**Application number 2020/4437/P seeking Planning Permission to develop telecommunications equipment at 25 Hampstead High Street, NW3 1QJ by Waldon Telecom Ltd on behalf of Cornerstone and Telefonica**

CLIENT	FREEHOLDERS
PROJECT	26-28 HANBSTEAD HIGH STREET LONDON NW9 1QA
TITLE	ROOF PLANS-PROPOSED ROOF TERRACE & TELECOM EQUIPMENT OVERLAD
DWG No	1120_SK021

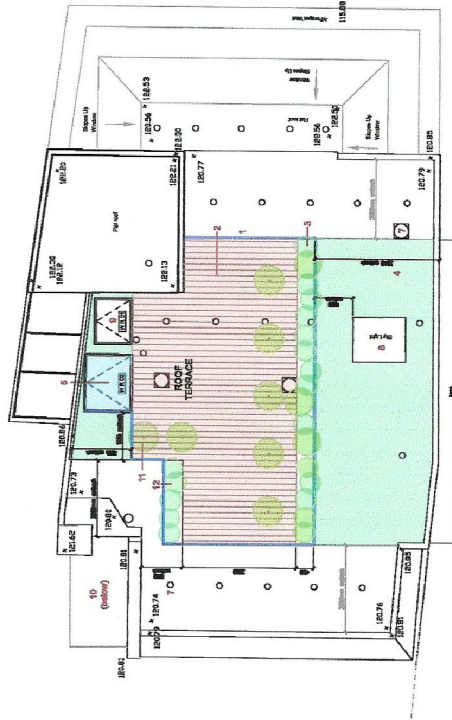
The proposed telecom equipment physically encroaches onto the proposed roof terrace in three locations (see drawing attached):

- a. The equipment fronting Gayton Road encroaches onto the glazed access roof, glazed balustrade, green roof, and decking.
- b. The equipment fronting Hampstead High Street encroaches onto the roof-light of Flat 5 and the green roof
- c. The equipment located at the rear of the building encroaches onto the glazed balustrade, roof decking, and planting.

Taking into account the mandatory public exclusion zones inherent to such telecom installations, the encroachment would of course be a lot more significant and make this already approved roof terrace worthless to the residents.
